UNITED STATES PATENT AND TRADEMARK OFFICE

Office Action Summary

10/777,496

DETAILED ACTION

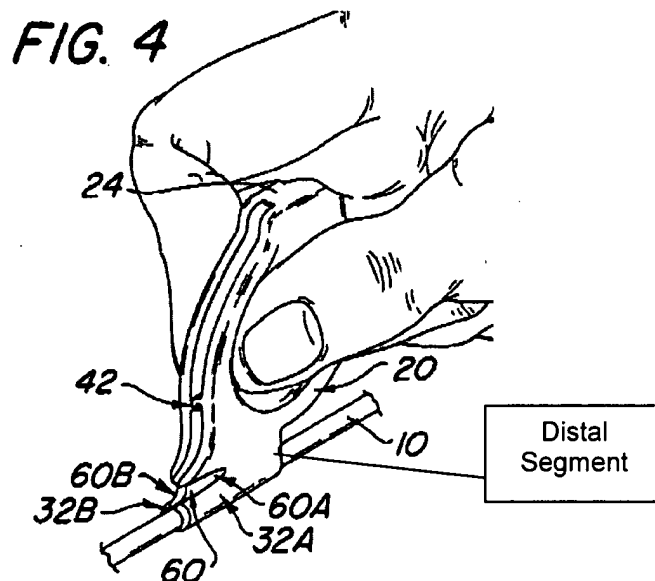
8. **Claims 1-4 and 9** are rejected under 35 U.S.C. 102(b) as being anticipated by Brenner (US 6,497,681 B1).

With regard to **claims 1 and 9**, Brenner discloses a device for removing a guide catheter from a linear lead (see entire document). The device comprises a body (20) having a front, rear, upper, and lower edge. As shown in Figure 4, Brenner discloses a central opening that is sized to engage the linear lead and therefore clearly overlaps the instantly claimed distal segment (column 5, line 66 through column 6, line 6).

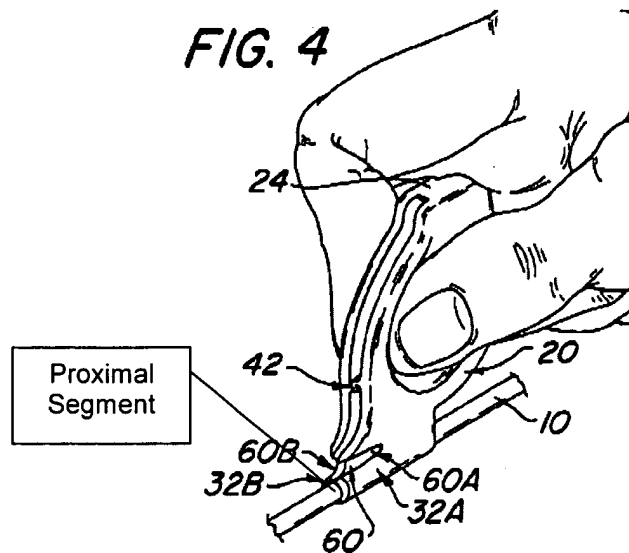
With regard to **claim 2**, as shown in Figure 1A the notch is positioned close to the distal segment and therefore clearly overlaps the instantly claimed proximate.

With regard to **claim 3**, Brenner also discloses an arcuate side opening forming a central opening and therefore overlaps the instantly claimed proximal segment. As shown below, the linear lead is inserted through the proximal segment central opening.

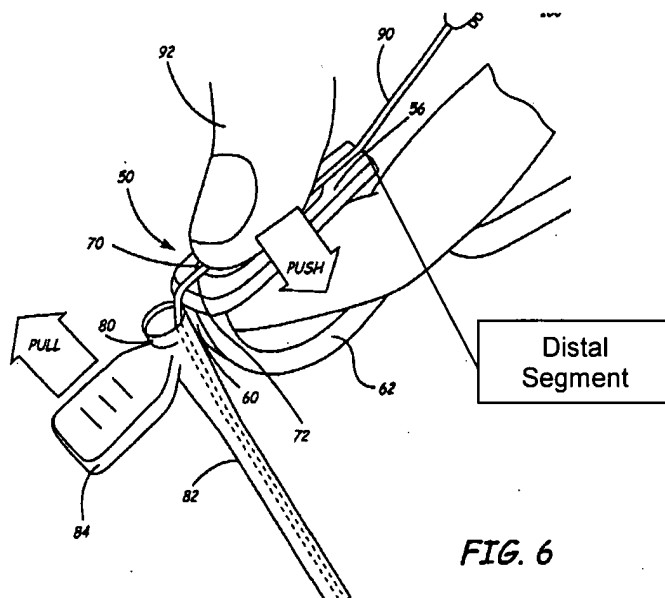
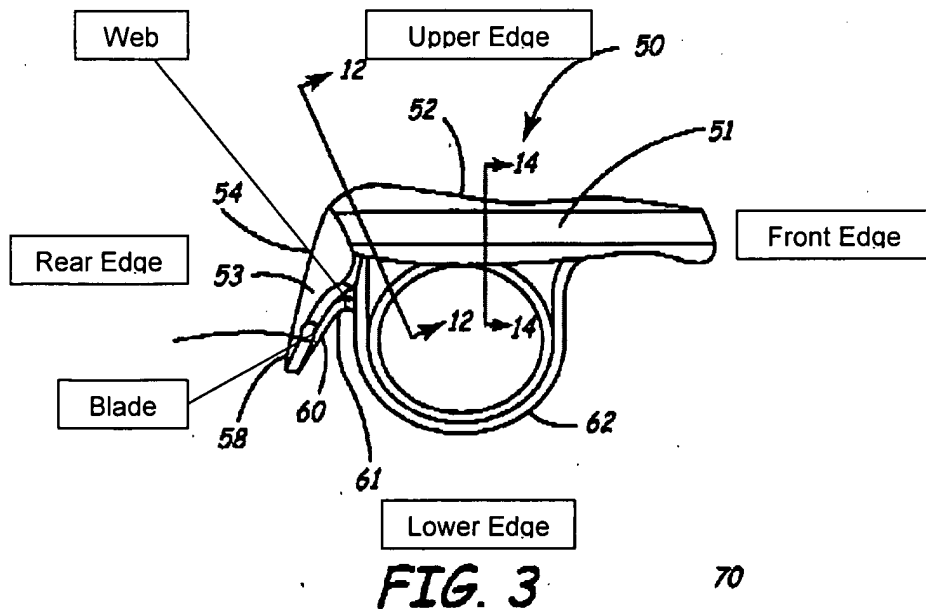
With regard to **claims 1 and 9**, Gardeski discloses a device for removing a guide catheter from a linear lead (see entire document). The device comprises a body (51) having a front, rear, upper, and lower edge. As shown in Figure 4, Gardeski discloses a

central opening (72) that is sized to engage the linear lead and therefore clearly overlaps the instantly claimed distal segment ([0050]; Figure 6).

A blade (60) is mounted between the lower edge and the distal segment and supported by a web extending from a segment between the lower edge and the distal segment (column 7, line 61 through column 8, line 10).

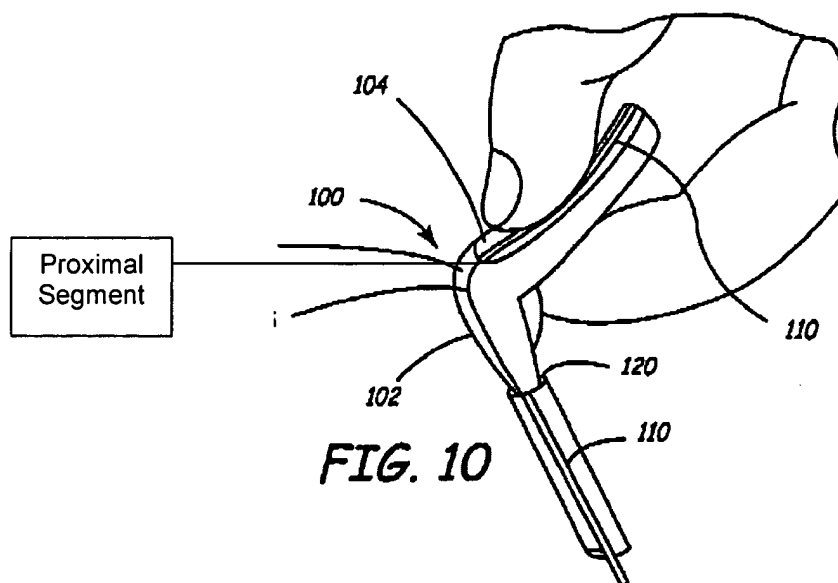
With regard to **claim 2**, since the cutting blade (60) is positioned close to the distal segment and comprises the notch, it is the examiner's position that the notch is proximate the distal segment (Figure 3).

FIG. 3

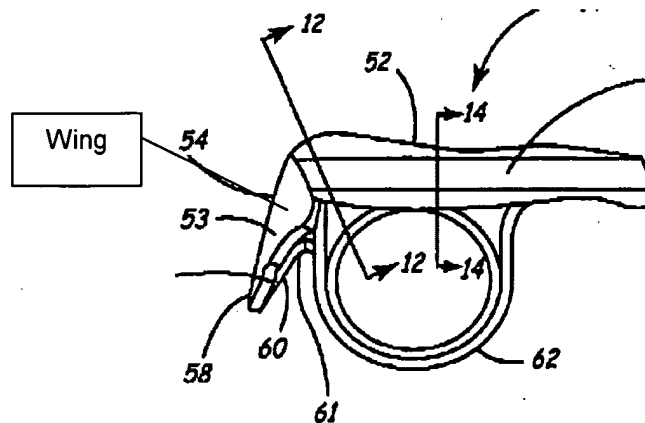
With regard to **claim 11**, Gardeski discloses laterally opposing wings, one of which is shown below.

FIG. 3

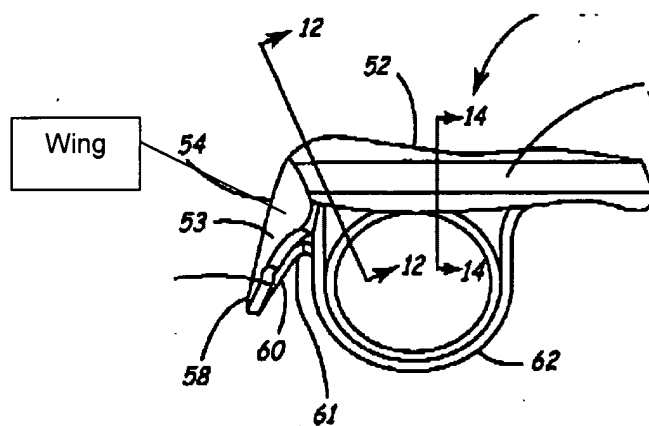
With regard to **claim 6**, Gardeski discloses laterally opposing wings, one of which is shown below.
